UPGRADING CIRCUIT BREAKERS FOR LCI HYDRAULIC PUMPS

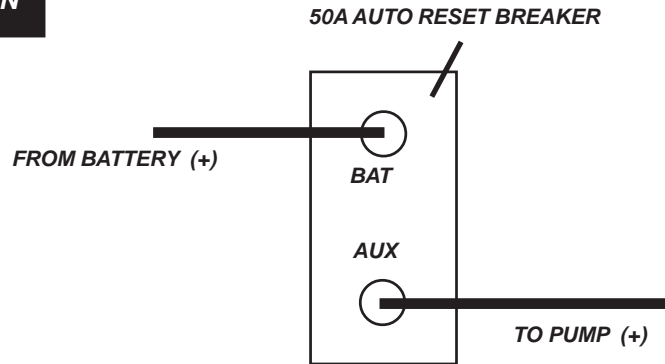
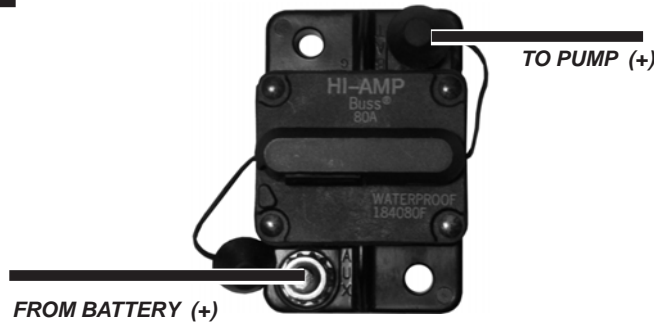
Due to high amp draws on hydraulic slideout systems, it may be necessary to upgrade the circuit breaker. During slideout operation, the higher amperage requirements on the hydraulic pump unit may cause the system to draw the voltage down. This voltage drop increases the amp draw and forces the 50A Auto Reset Breaker to trip and shut the system down. If the circuit breaker continues to trip, upgrading the 50A breaker to a breaker with a higher amperage rating will solve the issue without harm to the system. Wiring and breaker sizes are to be supplied by the RV Manufacturer. This applies to systems with and without individual room controls.

RV MANUFACTURER WILL SUPPLY THE MATERIAL INFORMATION FOR THE REPLACEMENT COMPONENTS
